Addendum No. 2
October 16, 2023

Project: **Harrisburg South Middle School Theatre Addition**
Harrisburg, South Dakota
Architecture Incorporated Project #3024

Scope of this Addendum:

4
5.41 DETAIL
SCALE: 1 1/2" = 1'-0"

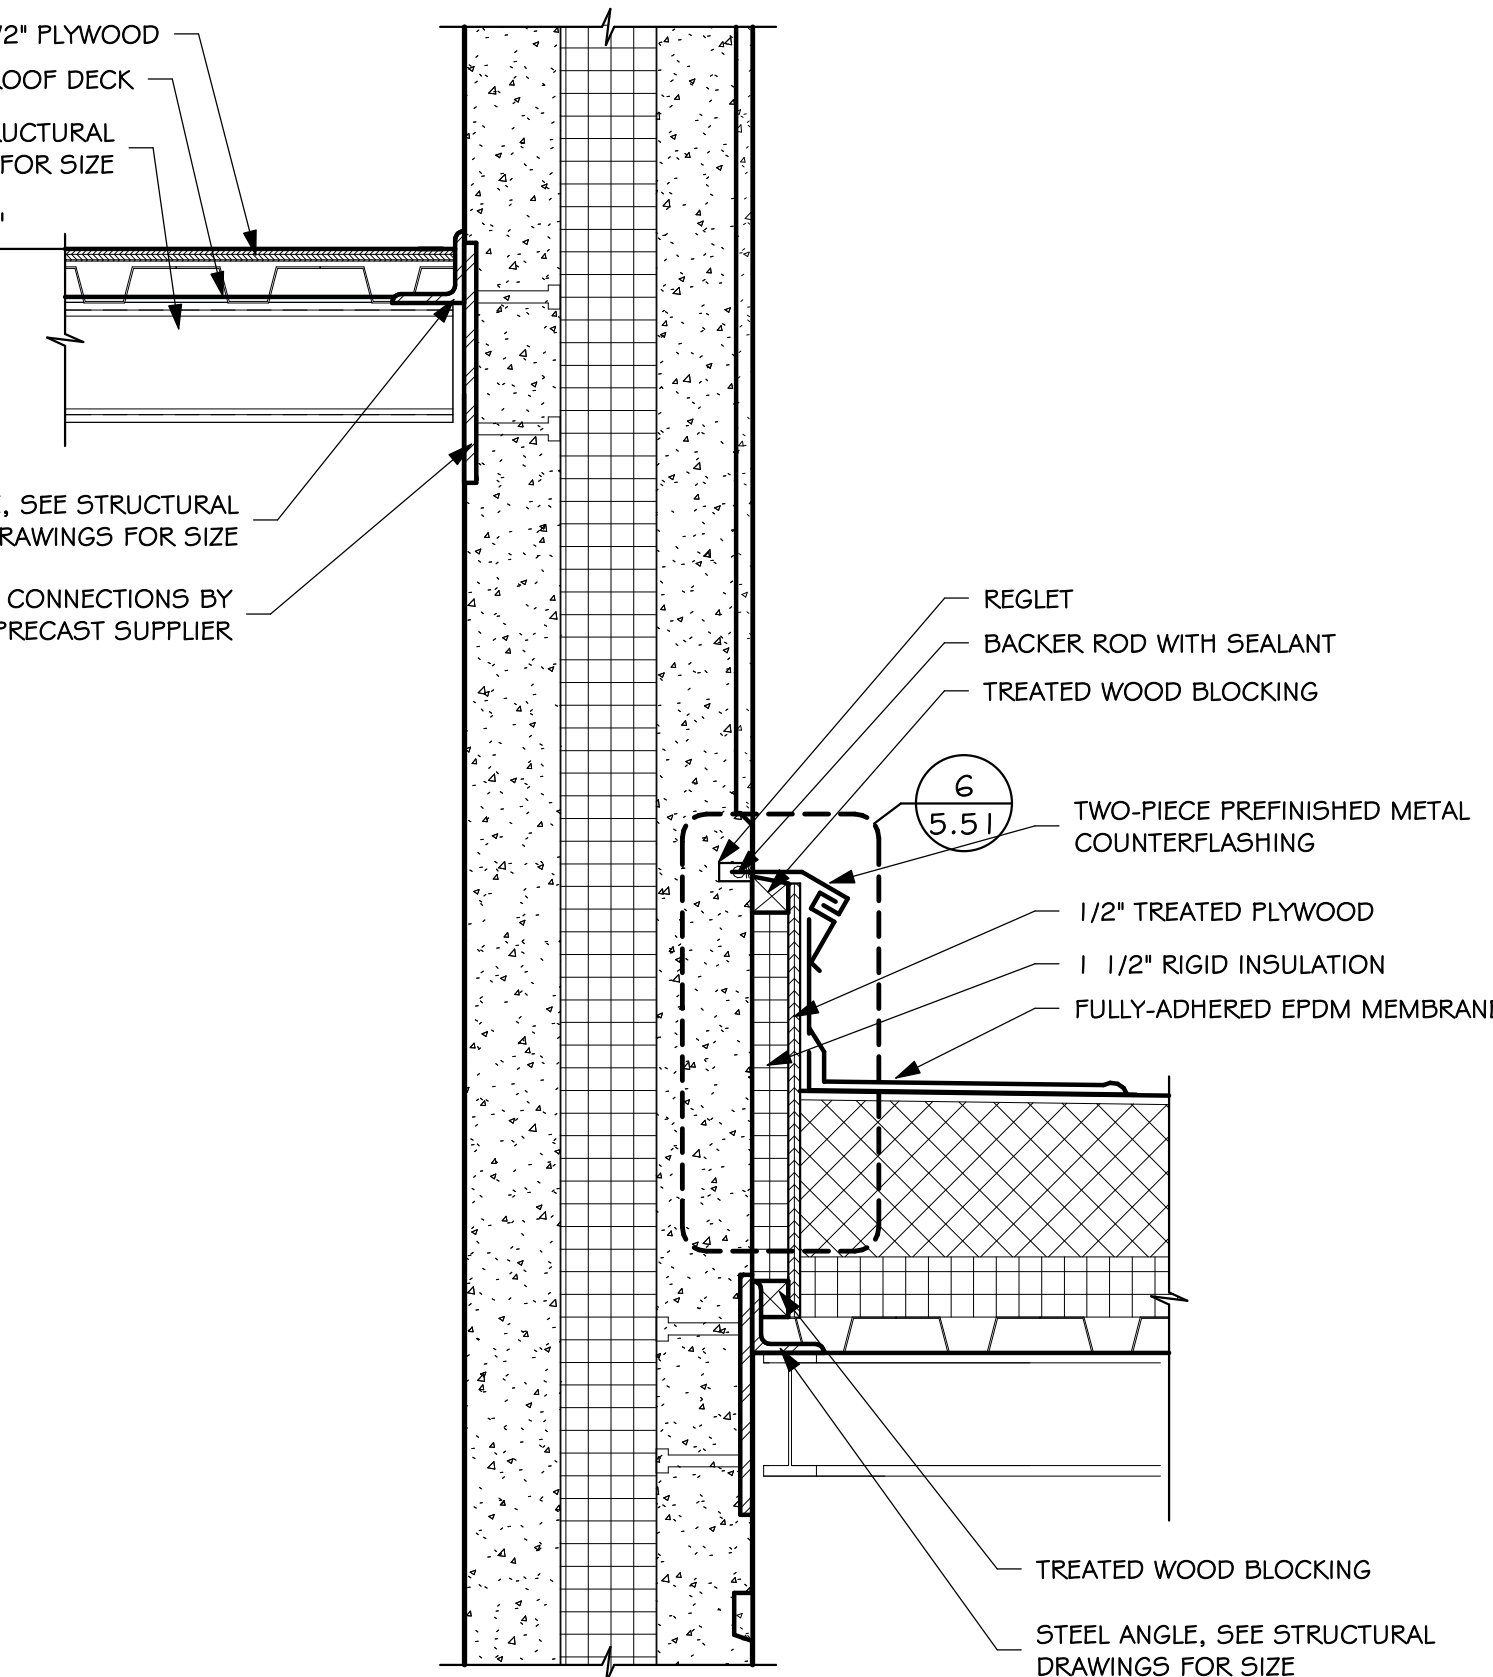
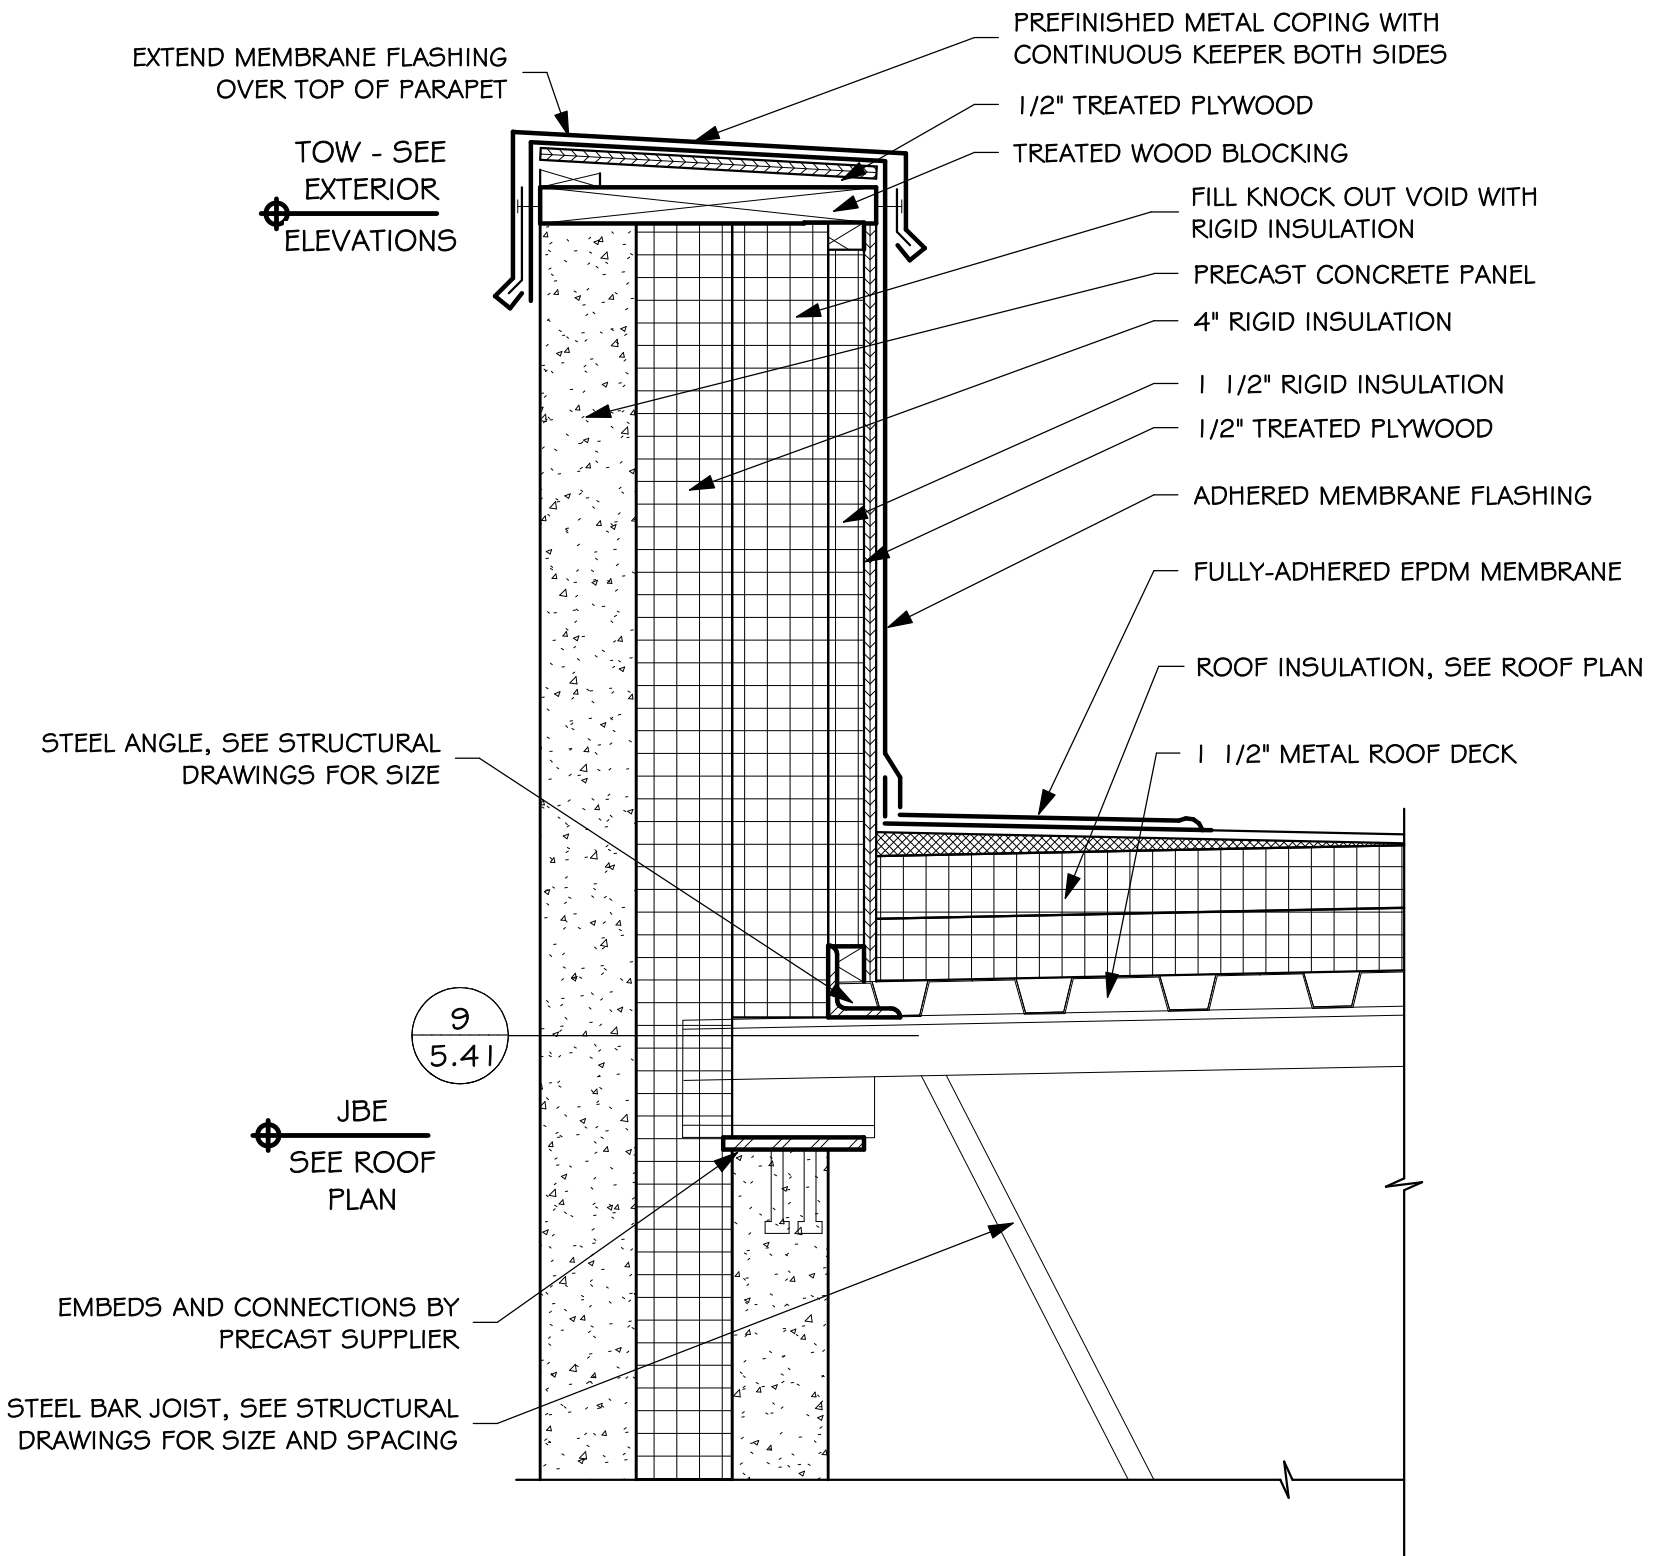
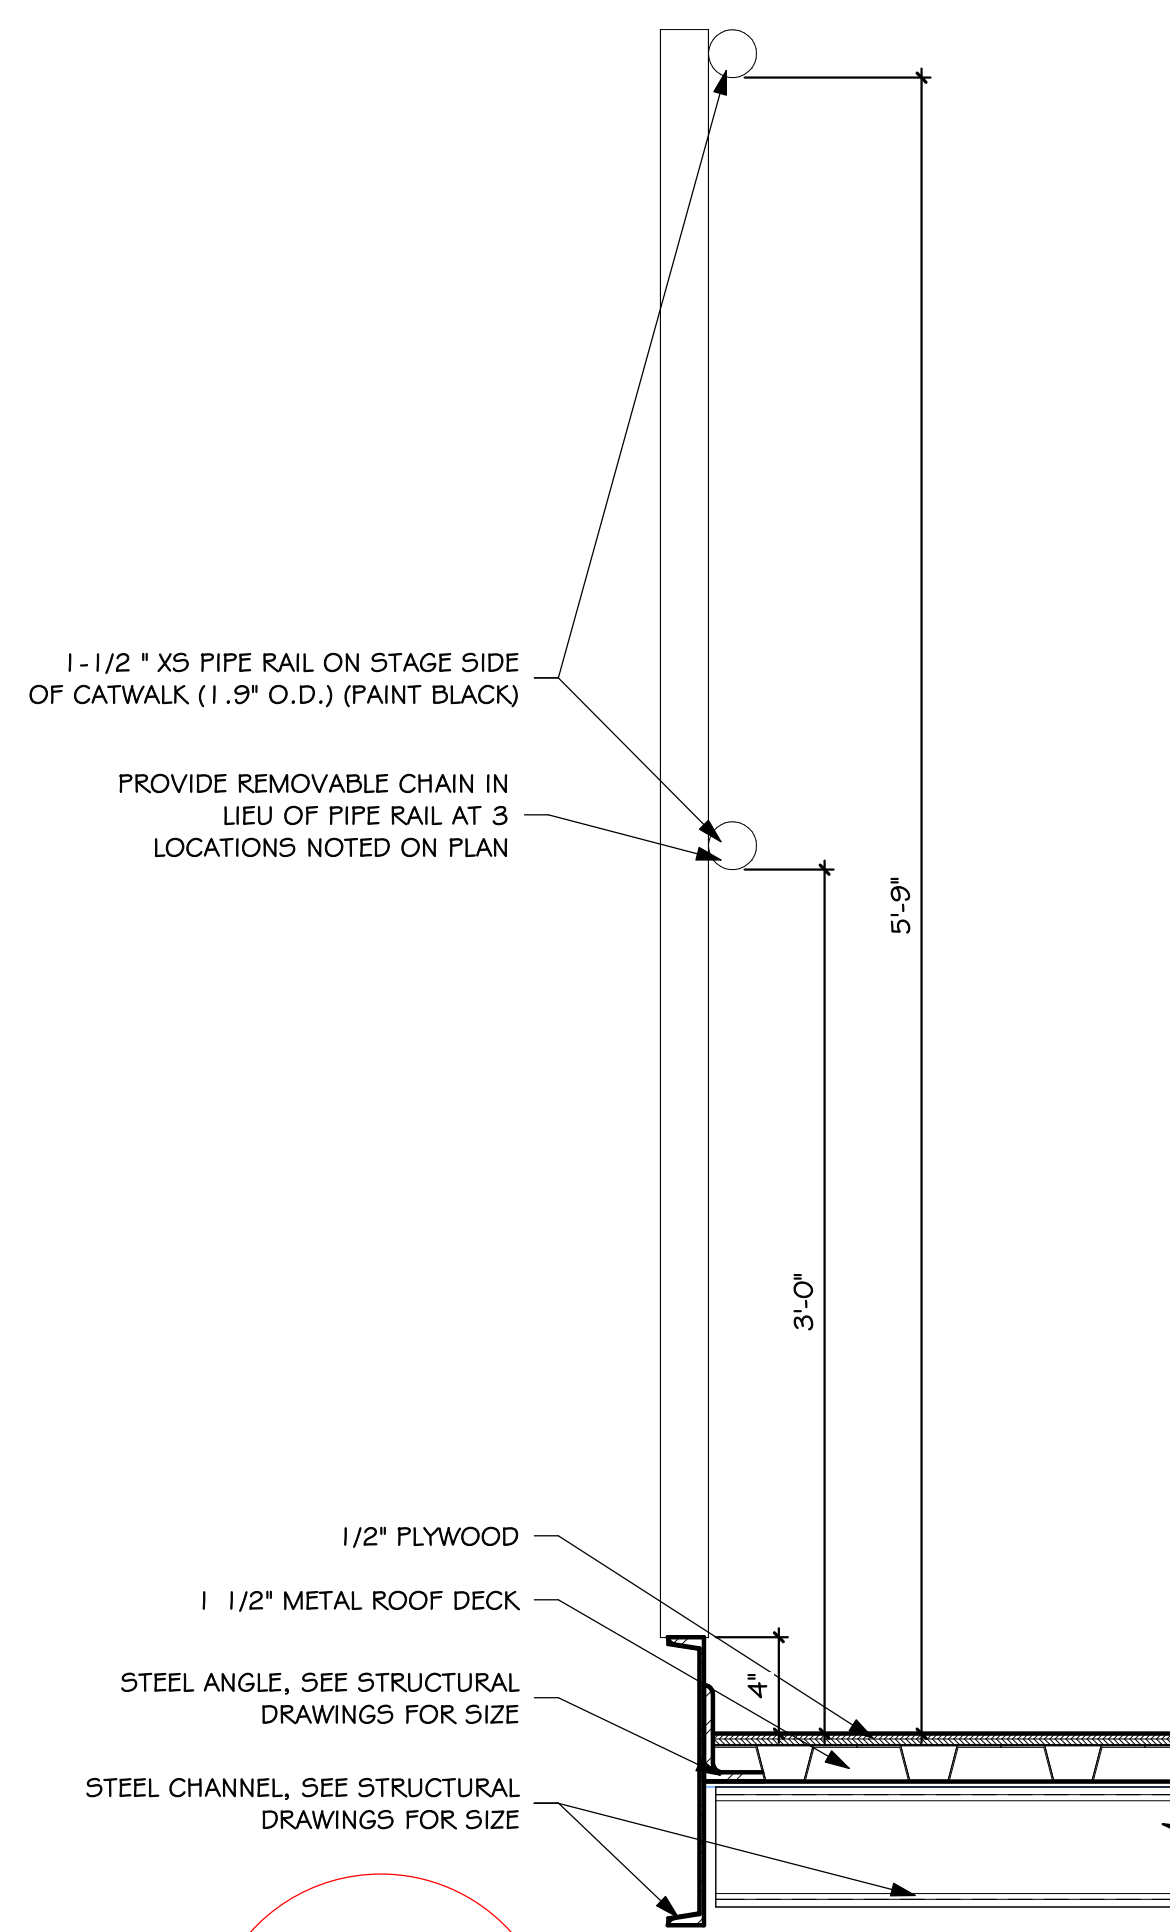
- a) See attached revised drawing 5.41 Section Details with revision date of 10-16-23 for the following revised details:
 - i) Catwalk detail 2/5.41
 - ii) Catwalk detail 3/5.41
 - iii) Detail 6/5.41 (Follow Spots catwalk at back of theatre).

1
6.20
DETAIL
SCALE: 3/4" = 1'-0"

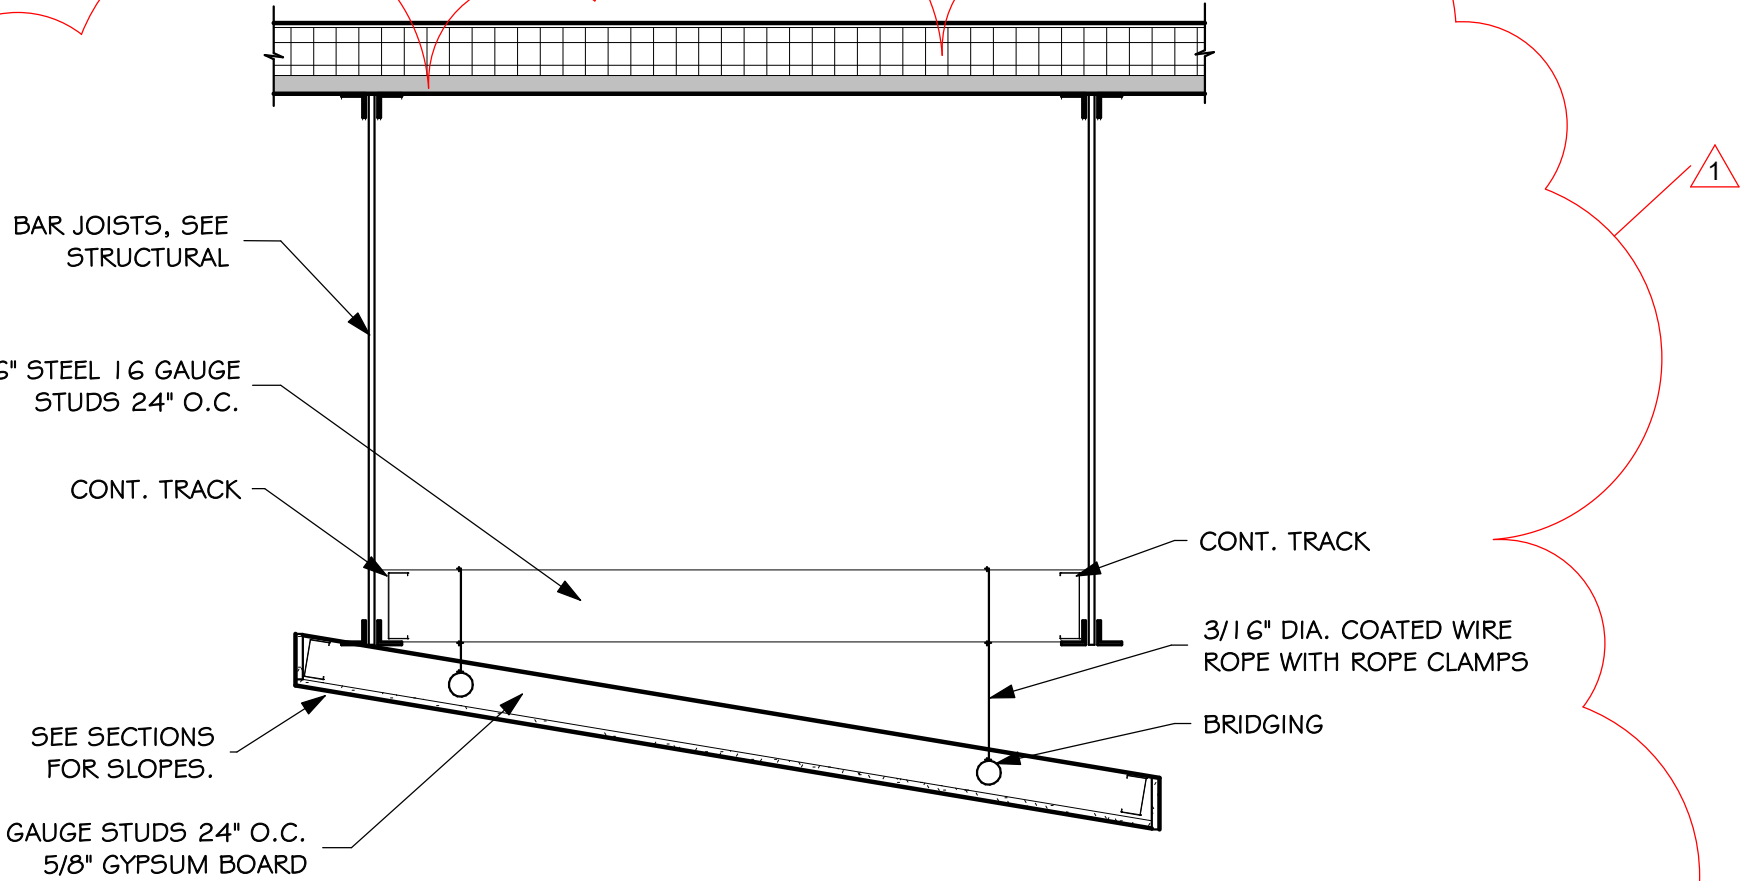
- a) See attached revised drawing 6.20 Ceiling Details with revision date of 10-16-23 for revised cloud detail 1/6.20.
- b) Detail 7/6.20 – change ‘**8” STEEL STUDS AT 16” O.C.**’ to ‘**6” STEEL STUDS AT 16” O.C.**’
